# Optimising Ensemble Streamflow Predictions with Bias-Correction and Data Assimilation Techniques: Response to reviewers

## **Authors response to comments from reviewer #1:**

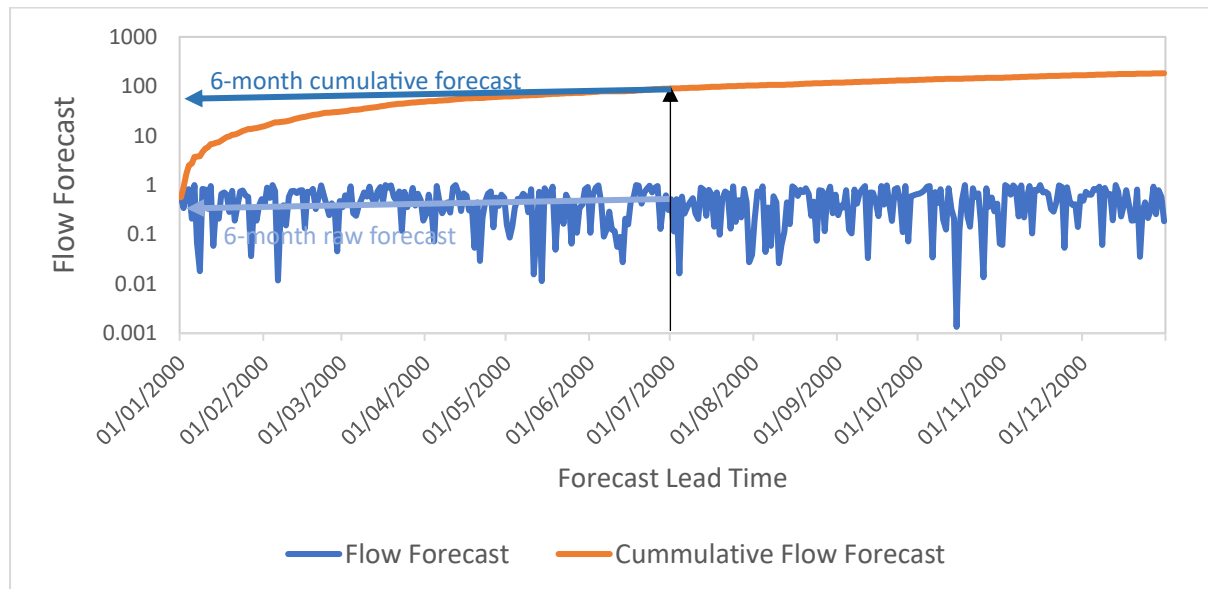
It may also be helpful to include more than one graphical schema to clarify this process. From my understanding, the 6-month forecast will include time series starting on 1964-06-01 (from the forecast launched on 1964-01-01) to 2016-05-31 (from the forecast launched on 2015-12-31 and would also include the months from 1964-07 (from the forecast launched on 1964-02-01), 1964-08 (from the forecast launched on 1964-03-01), and so on, until the last forecast month in May 2016. I assume, in a similar way, the time series for 30-day, 1-month, and 3-months were built. However, I am not certain if this applies to the 1-day, 3-day, 1-week, and 2-week forecast horizon.

Regarding the 6-month forecast, we would consider the accumulated 6-month flow (at the end of the full 6-month) to calculate the CRPSS rather than the value for the 6<sup>th</sup> month of

forecast (see Figure R1 for an illustration of this concept). The same principle applies to the 1-day, 3-day, 1-week, and 2-week forecast horizons, where the CRPSS was based on the total accumulated flow over the respective lead time forecast periods.

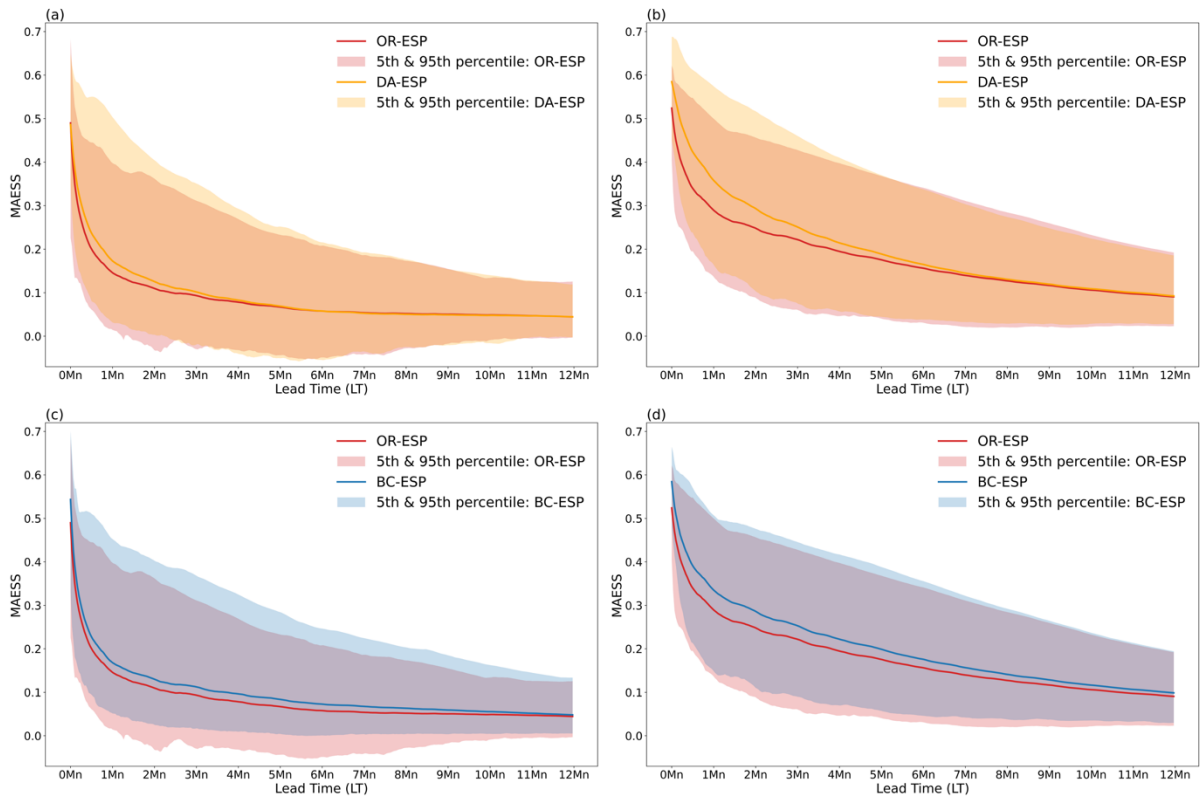
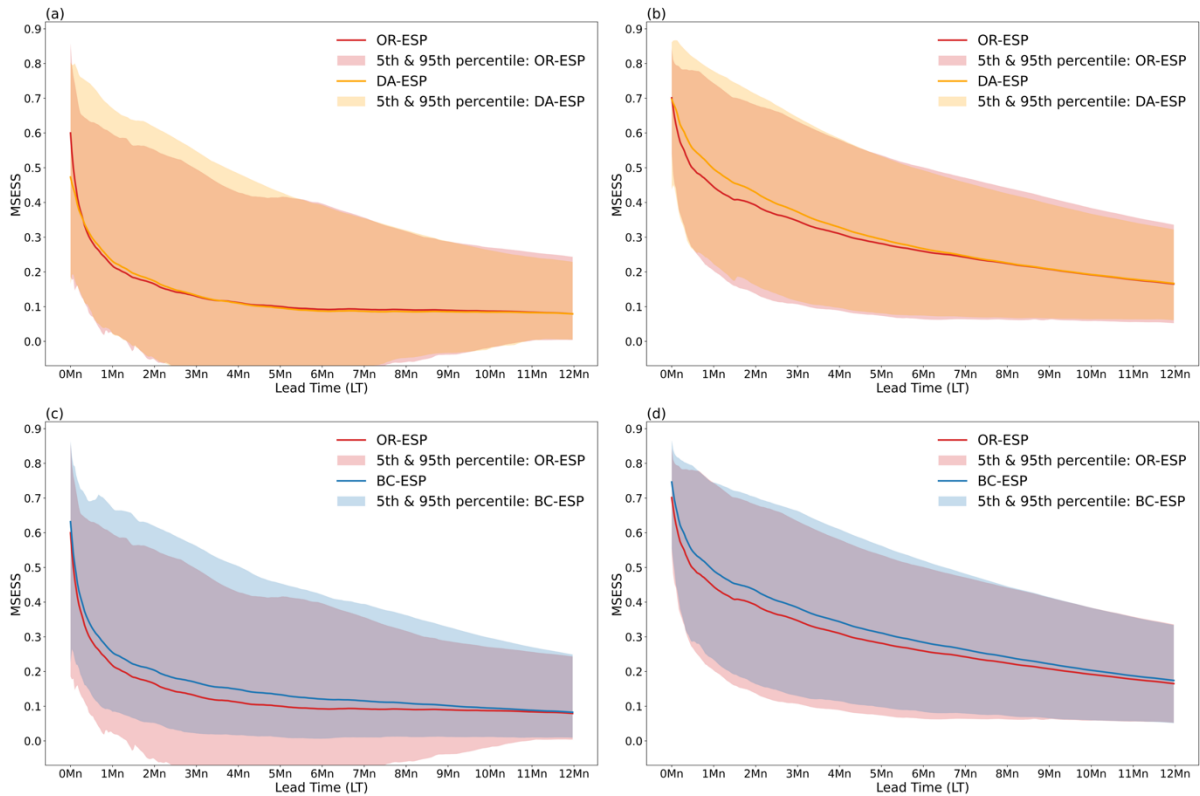
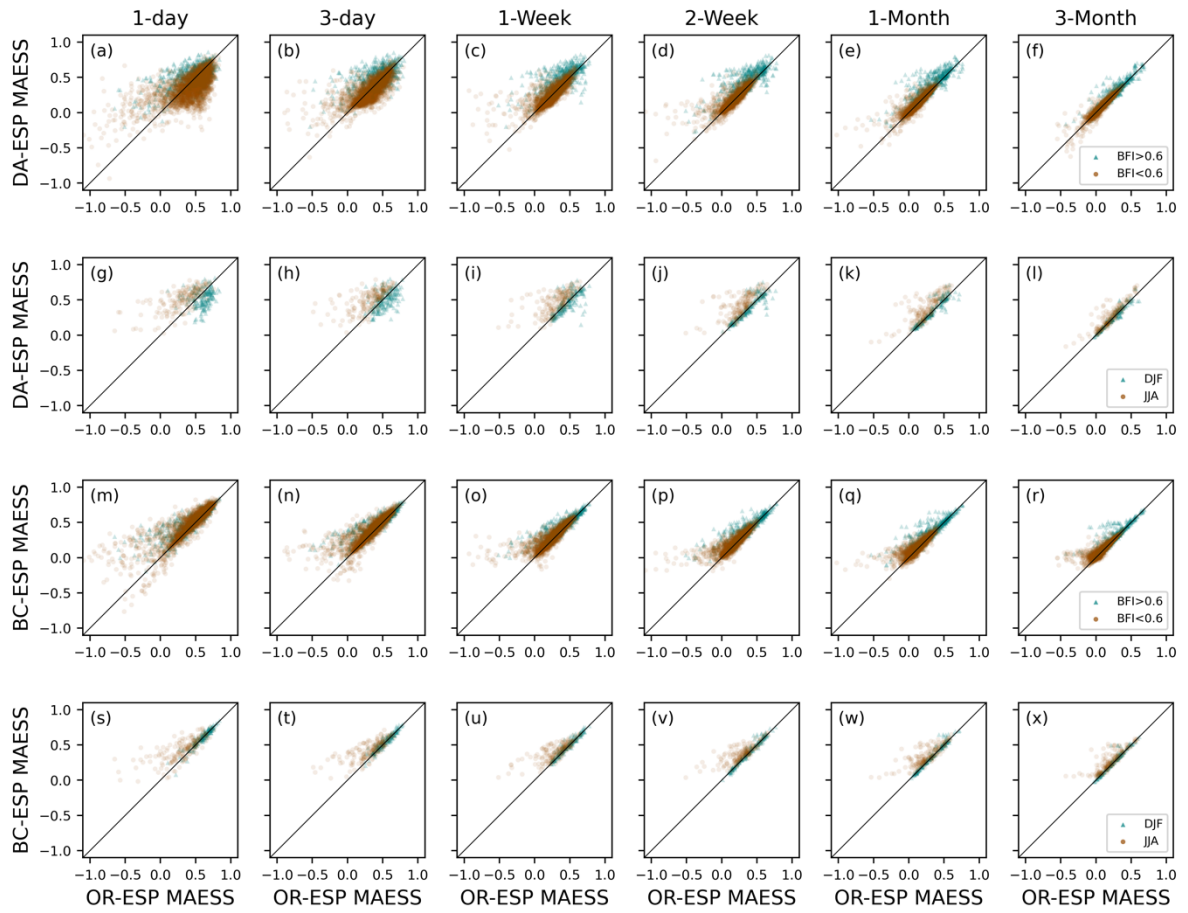
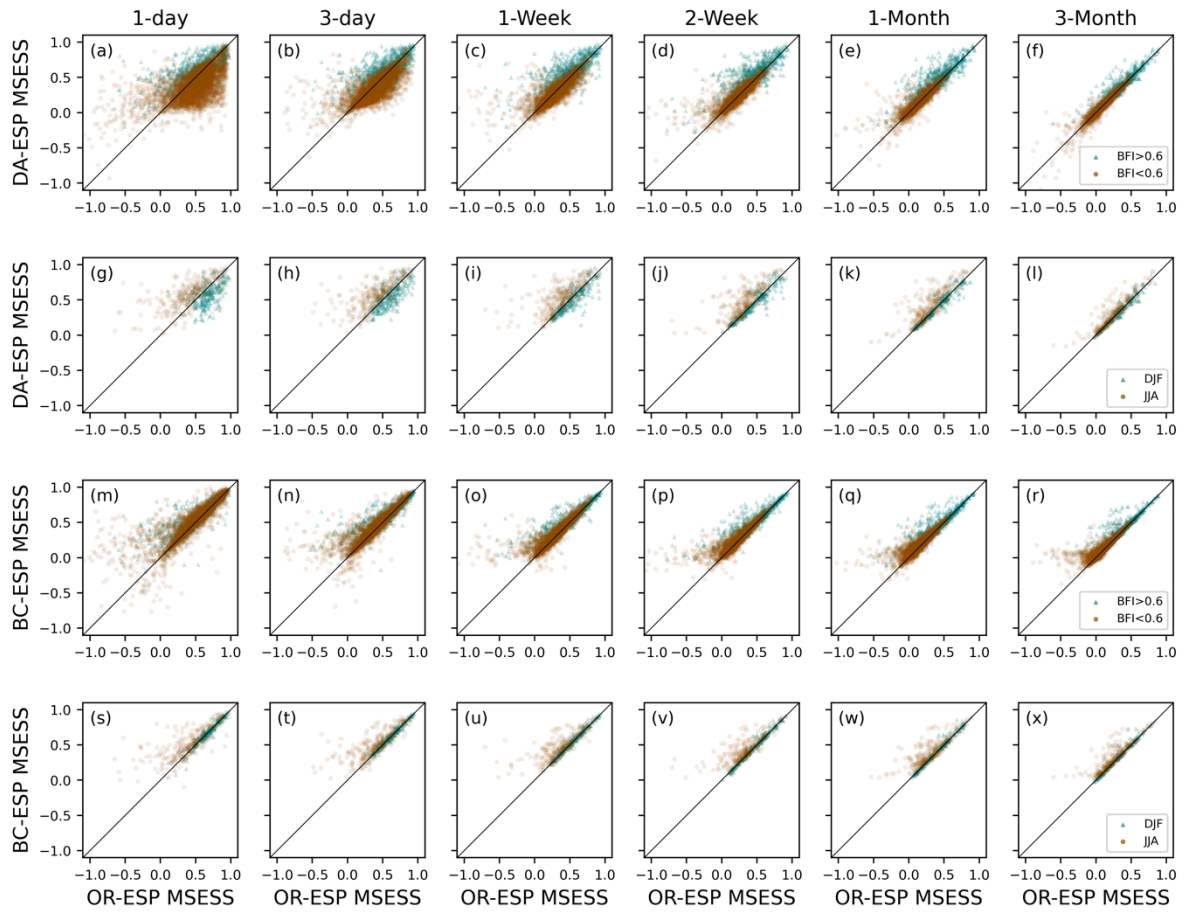
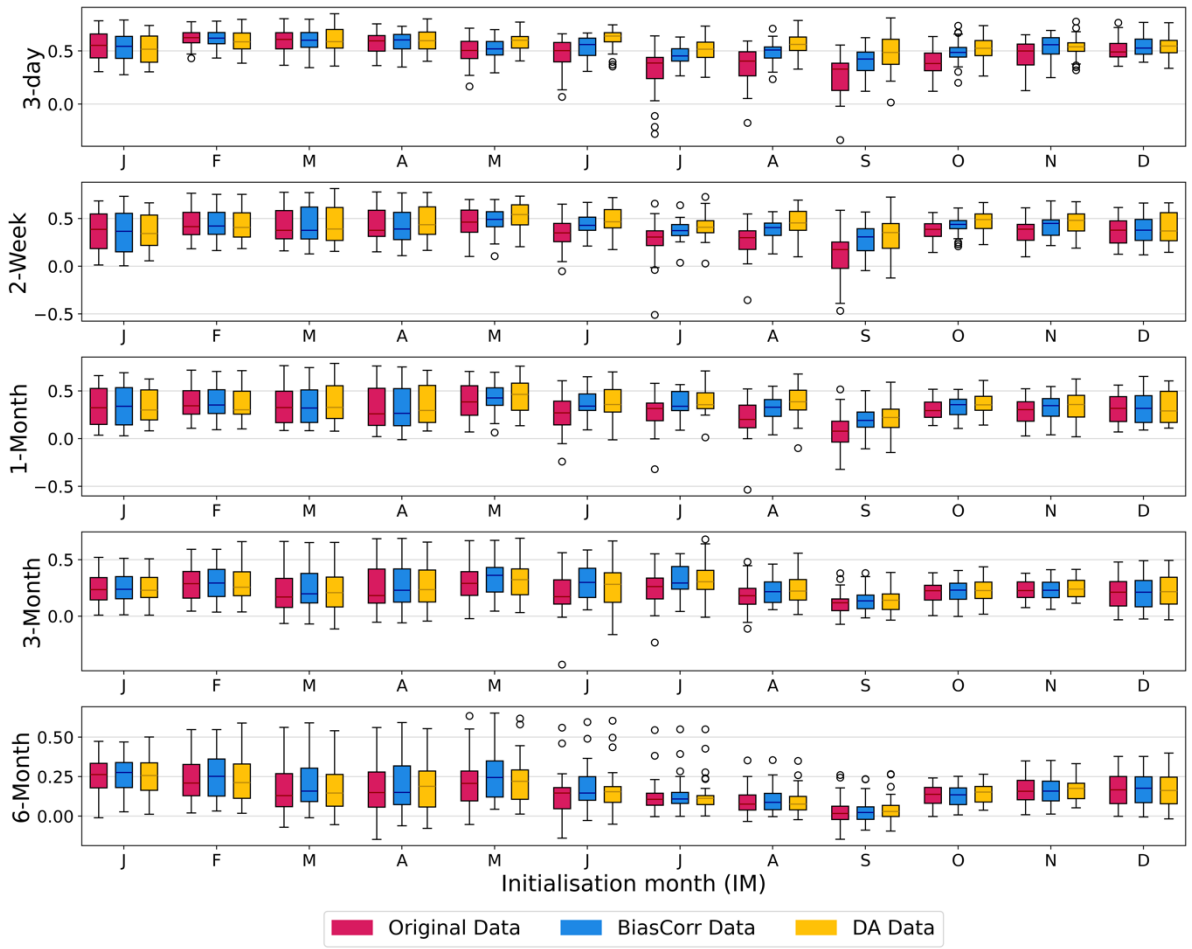
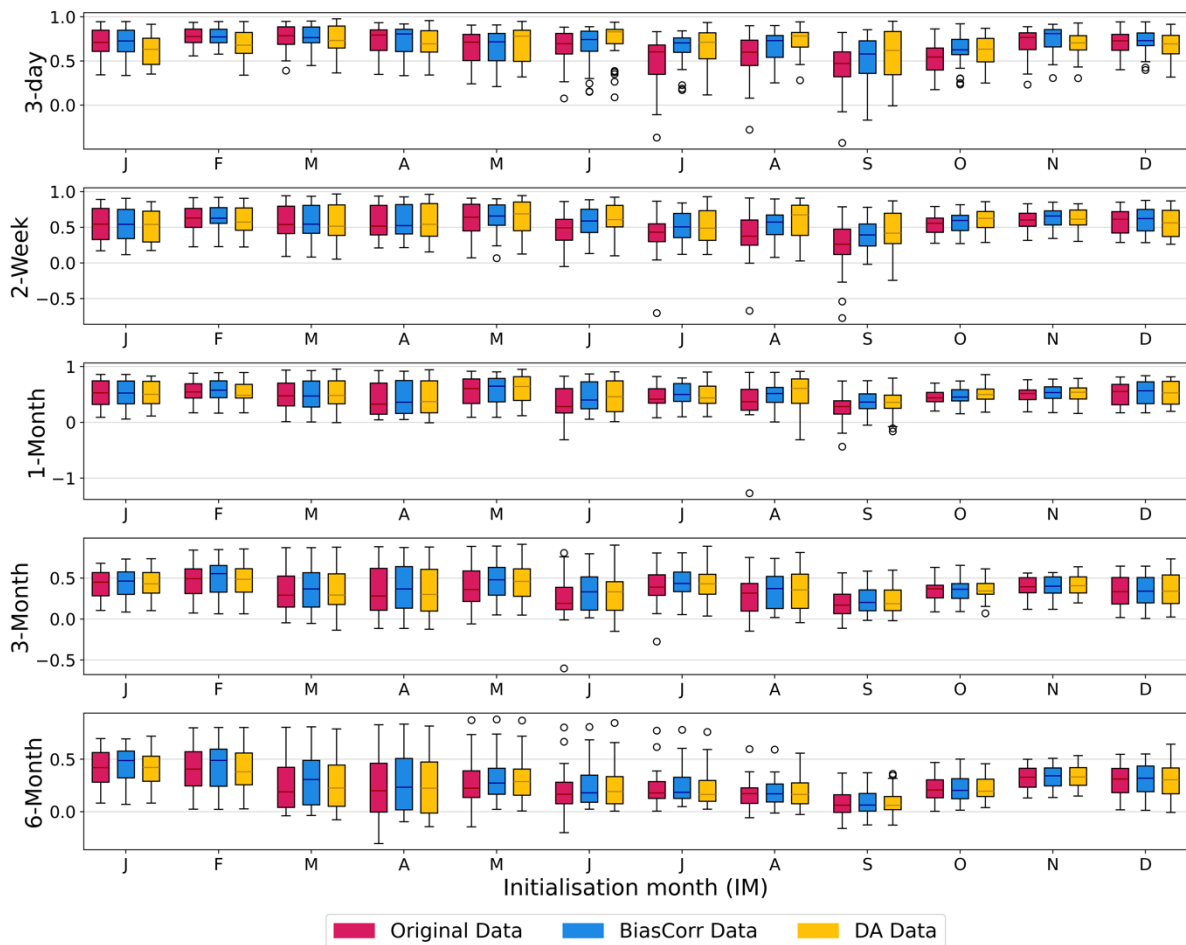
Furthermore, in Line 280, it is mentioned that the performance metrics from Section 2.5 were calculated for OR-ESP, BC-ESP, and DC-ESP. However, these metrics do not appear in the results (as Section 3.1 seems to focus on 'Simulated Observed River Flows'). Similarly, Lines 282-284 reference additional metrics such as MAESS and MSESS, but these are also not shown in the results. Would it be possible to include these results in supplementary material? This would allow interested readers to explore these metrics further.

Regarding the inclusion of MAESS and MSESS in the results, we believe that adding these metrics would not significantly enhance the value of the manuscript. The results for MAESS and MSESS are very similar to those obtained with CRPSS, and including them would not alter our conclusions. This aligns with the approach taken by Harrigan et al. (2018), who also calculated these metrics but chose to present only the CRPSS results due to the lack of significant differences observed across various metrics.

Furthermore, both MAESS and MSESS are deterministic skill scores, while our analysis is based on probabilistic forecasts. Therefore, we consider CRPSS to be the most appropriate metric for evaluating our forecast performance in this context.

We include in this response the versions for MAESS and MSESS of Figures 4 to 6, but we have not included them in the revised version for the reasons stated above.

Figure R8: Revised Figure 6

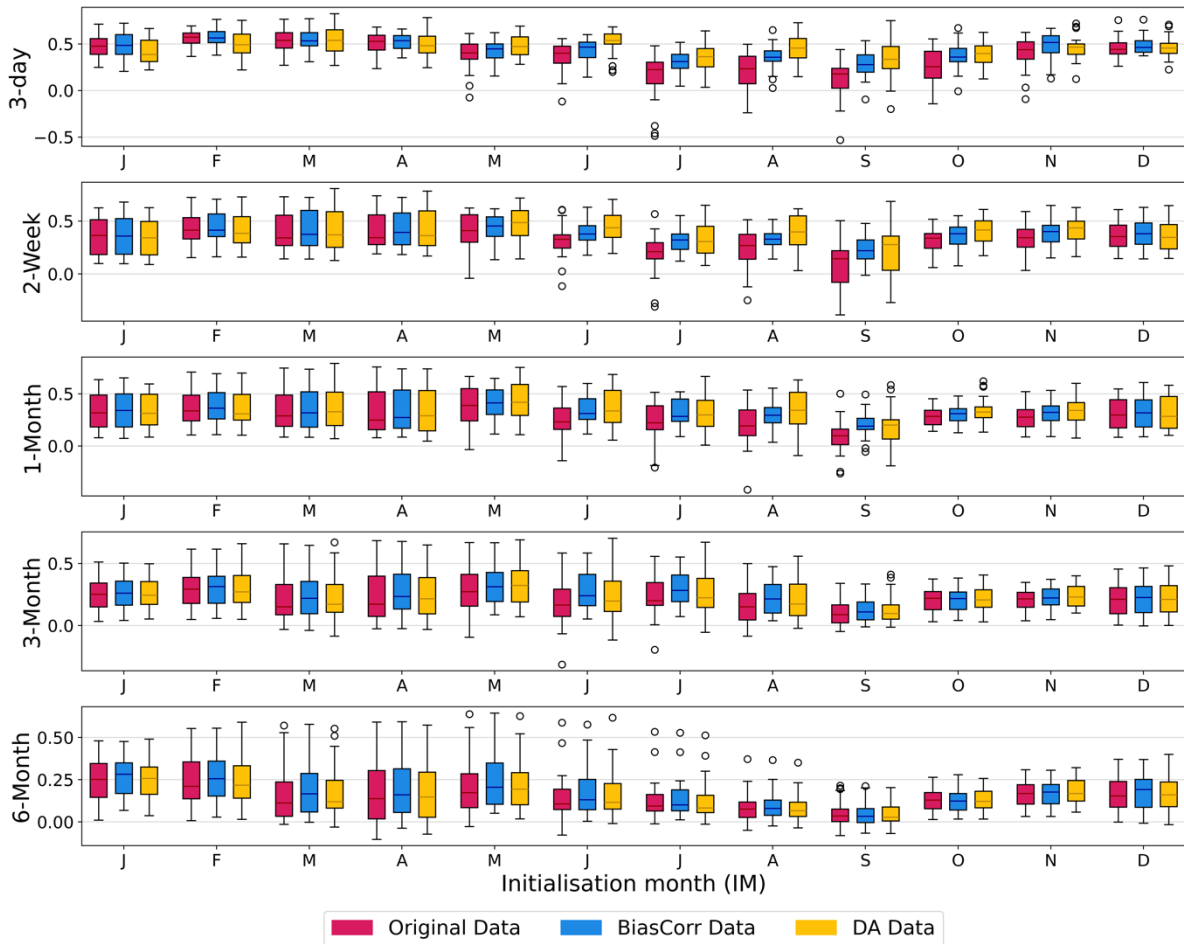
In Figure 6, I recommend placing the legend at the bottom to allow for a wider and taller plot, which would make it easier to see more details.

Thank you for the suggestion. We have made that amendment in the revised version. This is the revised Figure 6:
